Project: IEEE P802.15 Working Group for Wireless Personal Area Networks (WPANs)

Submission Title: [Proposed resolution for comments on data flow processing order, w/r/t FEC and DataWhitening, for MR-FSK PHYs]Date Submitted: [May, 2010]Source: [Daniel Popa, Hartman Van Wyk]Company [Itron, Inc.]

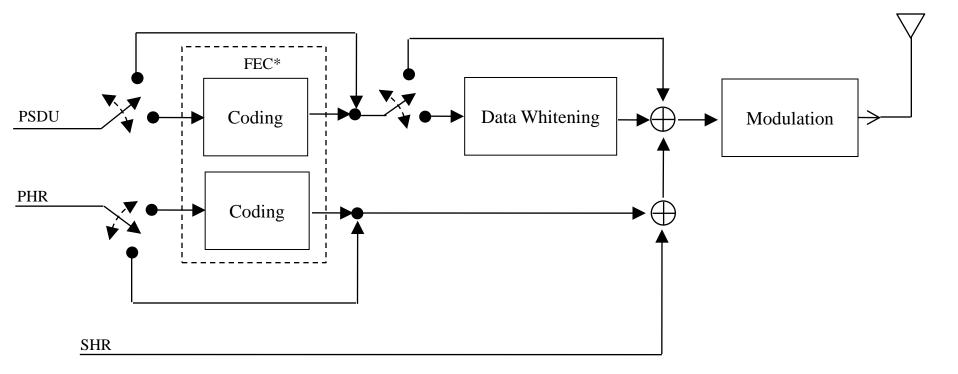
This proposal can potentially provide a resolution for the following comments: 1233, 1264, 1273.

* When FEC is enabled, PHR and PSDU shall be coded as a single block of data, as described in <Insert correct subclause number>
